[Docket No. 93-CE-54-AD]

Airworthiness Directives; Cessna Aircraft Company Engine Oil Filter Adapter Assemblies Installed on Aircraft

ACTION: Supplemental notice of proposed rulemaking (NPRM); Reopening of the comment period.

Figure 1. Oil Filter Adapter Installation

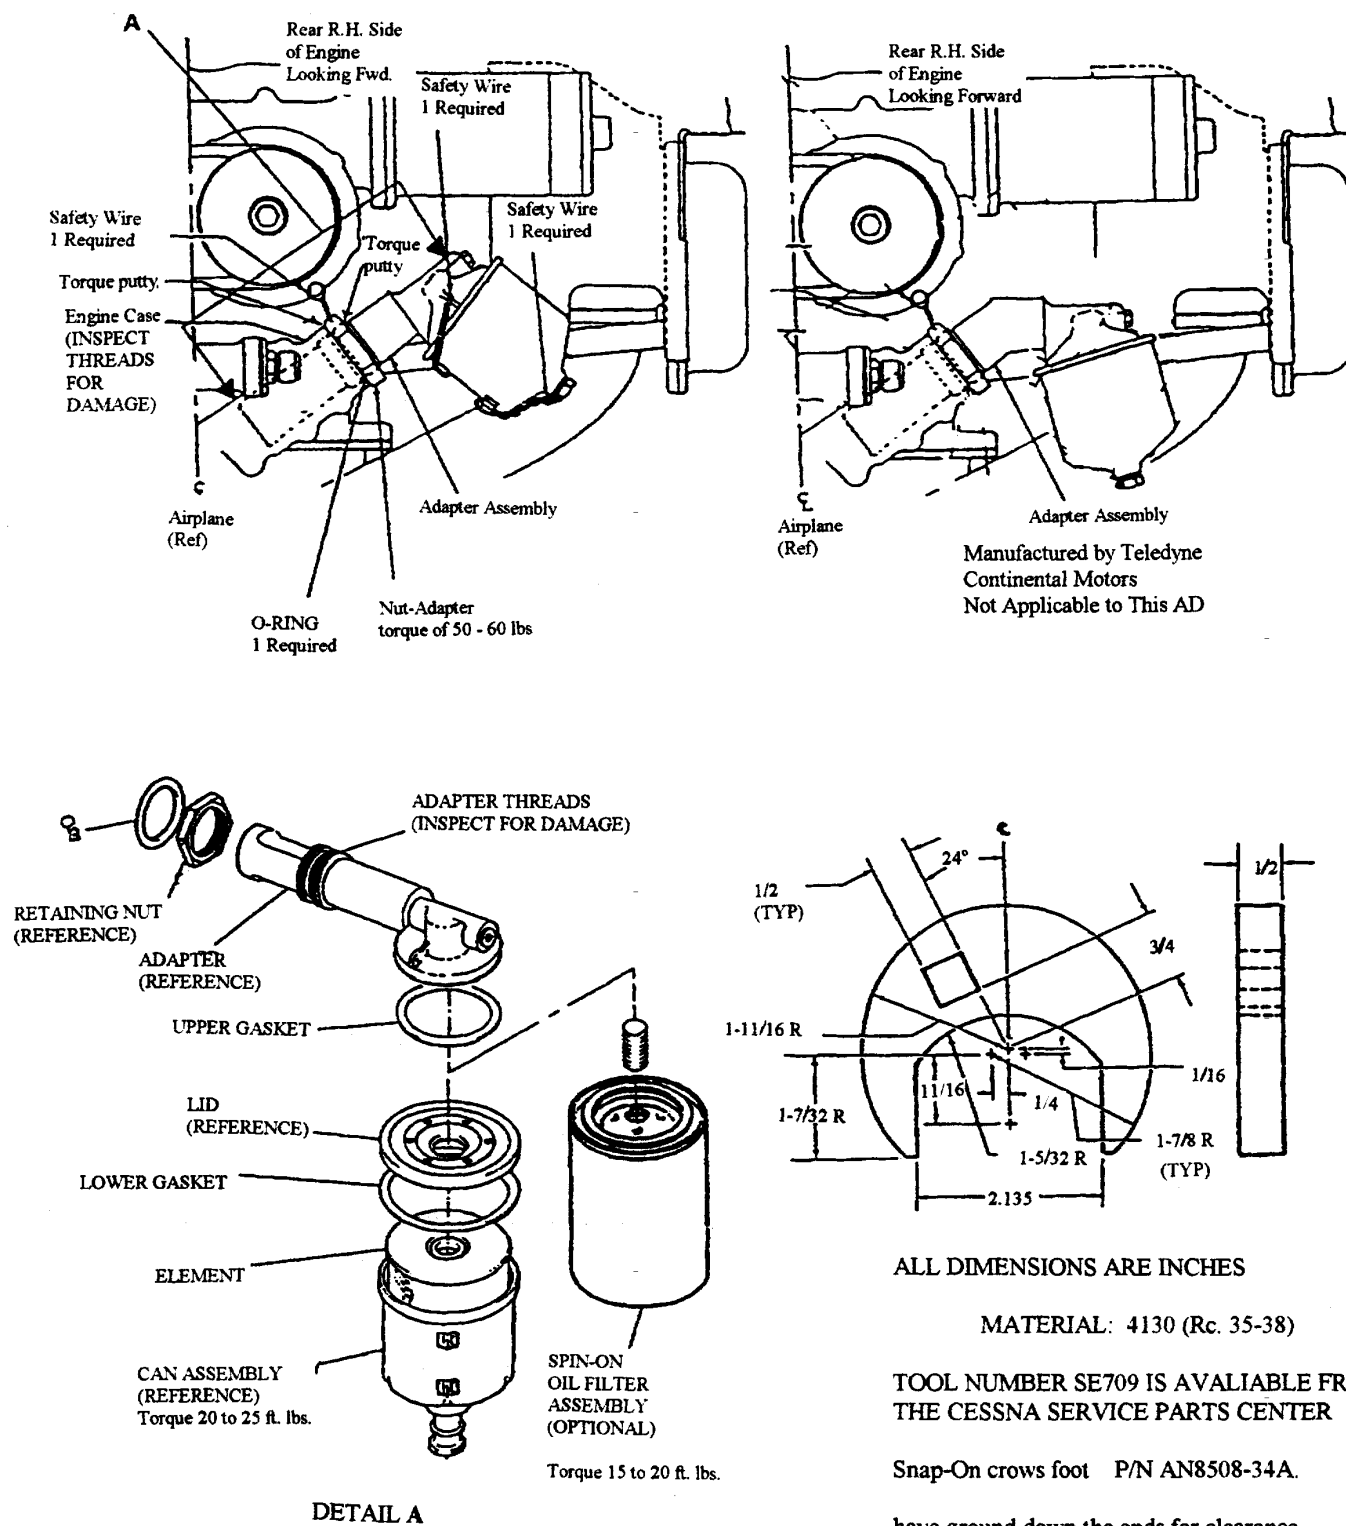
The Cessna Pilots Association (CPA) recommends that the FAA include a drawing in the NPRM to aid in accomplishing the proposed AD. The FAA concurs, and has developed and incorporated Figure 1 into the proposal.

Note 2: This AD does not apply to engine oil filter adapter assemblies manufactured by Teledyne Continental Motors (See Figure 1 of this AD).

(4) Apply torque putty between the engine filter adapter assembly, nut, and oil pump housing as specified in Figure 1 of this AD.
